Subject: Request for Approval of Alternate Procedure  
Landfill Sideslope Subbase Design and Horizontal Separation to Property Line  
Citrus County Central Landfill Phase 2 Expansion

Subject: Citrus County Central Landfill - Phase 2 Expansion  
Permit No.: #21375-004-SC, Citrus County

On behalf of Citrus County, SCS Engineers (SCS) submits the following responses to your request for additional information in a letter dated November 15, 2002. For ease of review, each FDEP comment is reiterated in bold type, followed by our response.

**Liner Stress Analysis - Weight of  
Liner, Protective Sand, Refuse, and Equipment Load on Side Slope**

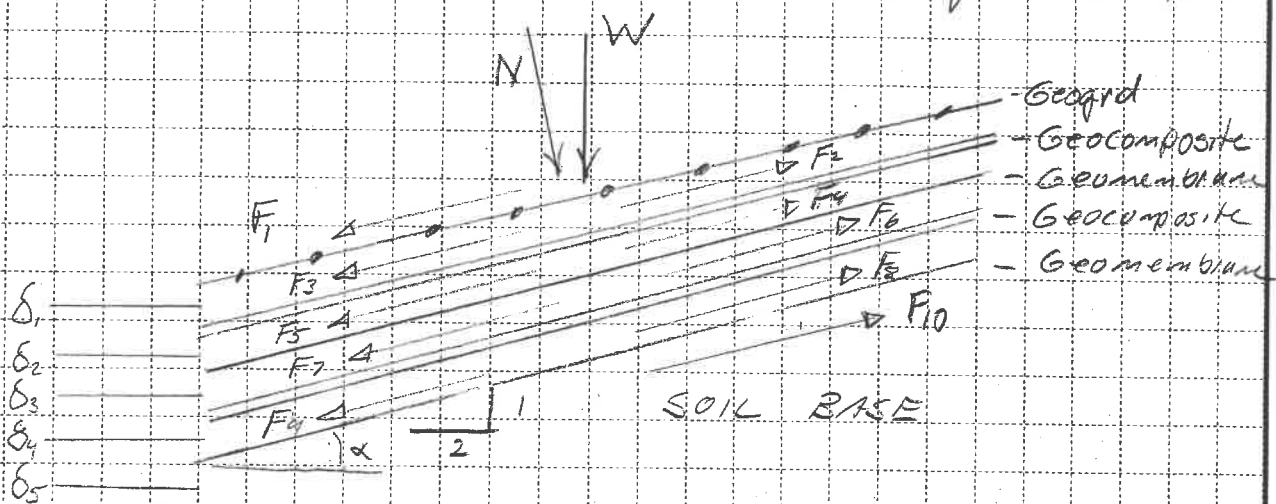
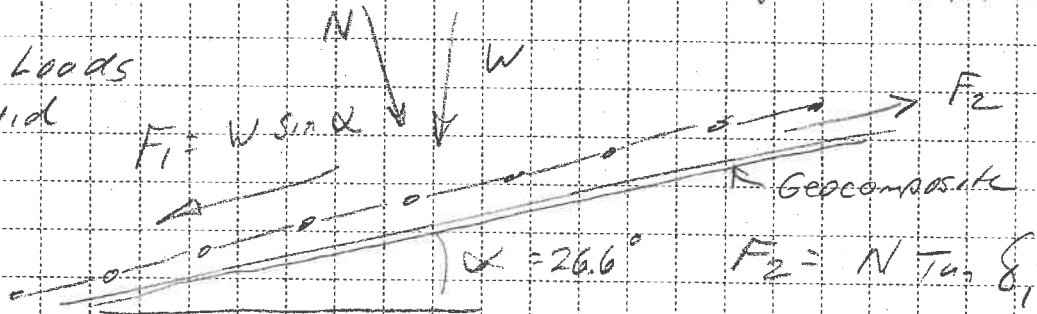
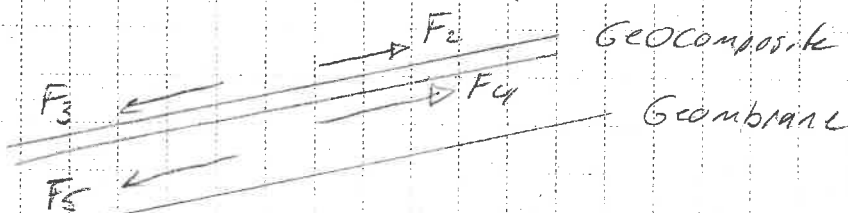
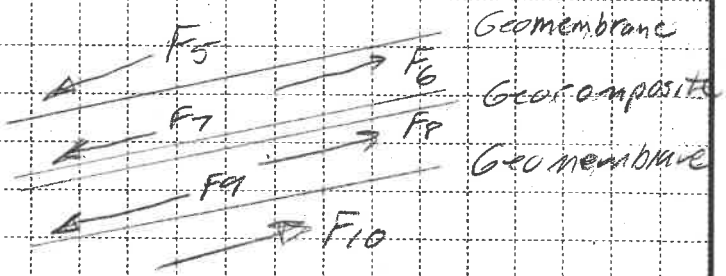
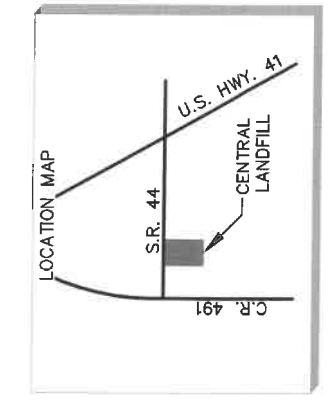
4. **62-701.400(3)(a)1. The rationale for calculating the factor of safety for the internal sideslopes is unclear. Technical documents are requested that support the assumption that the "resistance" to the downslope force (used for calculating the factor of safety) is the sum of the individual resistances provided by each component rather than the resistance of the weakest component (being the geonet). A copy of each of the "technical reference reports on the subject of liner analysis on side slopes" mentioned in Section H.2.a.1 are requested. Each component of the liner system must be able to withstand the stresses imposed by the component's own weight with the weight of the 24-inch sand layer, and any potential down-drag forces from the ongoing compression of the waste, on 2H:IV side slopes with the condition of operating heavy equipment for spreading and compaction. Design calculations must be based on friction angles from published data and confirmed by the actual results from shear box tests for the proposed design.**

**Response:** Please see the enclosed calculations for liner system stress. We have included the use of a geogrid on the 2:1 sideslopes to add an additional factor of safety. The resulting calculations show that no stress is applied to any of the geosynthetic liner system materials. The geogrid specified can withstand the downward force calculated using methods prescribed by Koerner plus the addition of the landfill compactor and maintain at least a 1.5 FS with only 5-percent strain on the material. A portion of the downward force is transferred to the bottom interface due to frictional forces within the liner system layers. The friction angles of the interface between the geogrid and the geocomposite, geocomposite and textured HDPE 60-mil geomembrane, and the textured geomembrane and the bottom soils will be measured with the actual materials to be used on the project. The resulting values will be compared to the values used in these calculations and the factor of safety will be verified.

**Response:** Please see the enclosed revised specifications for geomembrane, geogrid, and geocomposite products that incorporate the requirements of Rule 62-701.400(3)(d) 7., 10., and 11., FAC. Please note that the angle of the slope and the friction angle of the materials are related only by the fact that the steeper the angle the lower the normal

be. The fact that the slope angle is steeper than a given friction angle does not mean there will necessarily be a failure or stress applied to a material. The entire calculation must be evaluated to make this determination.
